Service Dunetin					
<b>SB No.: 013 issue 4</b>	CCAR No.: None	Classification:			
Aircraft type & model (applicability)	Aircraft serial Nos. effected	<b>OPTIONAL</b> or			
RotorSport UK MT-03 series	RSUK/MT-03/all	RECOMMENDED or			
Rotoroport or wir of series	KSOK/WIT 03/all				
		MANDATORY			
This form is the response from RotorSport U					
requiring a containment or rectification action					
Upon completion of the action, the person res					
the SB and/or CAA MPD (Mandatory Permit					
For help, contact RotorSport on 44(0)1588 6		org.			
Problem description & cause of problem if ki	nown				
Problem; The MT 02 corrige on MTOW of 450Kg, lim	ited in angineering terms by the g	transth of the guarancian hour. The			
The MT-03 carries an MTOW of 450Kg, lim market wants the aircraft with an MTOW of 5					
	sookg, which is now proven and	accepted on the MTOsport.			
Problem solution:		Effective date:			
Upgrade the MT-03 suspension bow by repla		rt 05.01.2010

### **Service Bulletin**

SB No.: 013 issue 4	CCAR No.: None	Classification:
Aircraft type & model (applicability) RotorSport UK MT-03 series	Aircraft serial Nos. effected RSUK/MT-03/all	- OPTIONAL or RECOMMENDED or
		MANDATORY

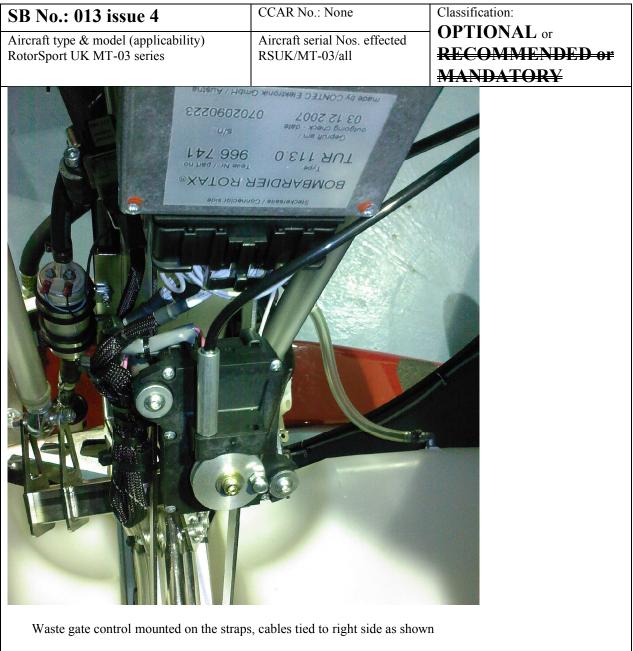
the supporting bracket removed by drilling out the rivet heads. Tie to one side.					
6. Using a CAA A8-10 Approved welder for the aircraft and welding type, weld in the straps as per the					
sketch and instructions under later in					
		hieved by clamping them in position			
and offering up the box for fitting be		- ,			
<ol> <li>Refit the removed components, using new nylock nuts and Loctite 243 on any plain fastenings.</li> </ol>

SD 1001 US ISSUE 4OAircraft type & model (applicability) RotorSport UK MT-03 seriesAircraft serial Nos. effected RSUK/MT-03/allO	Service Buildin					
RotorSport UK MT-03 series RSUK/MT-03/all	assification: <b>PTIONAL</b> or					
-	ECOMMENDED or					
	IANDATORY					
View of straps welded in place The straps are welded at 35 degrees to the mast.

Position and clamp the parts in place Set the TIG welder for job +ve, electrode -ve. Using an electrode 2.4mm diameter, filler metal 316 stainless steel and heat-setting 60-70amps produce continuous fillet welds in a single run. Ensure that filler metal is present in the whole welded length so that a joint "fused only" is not created.
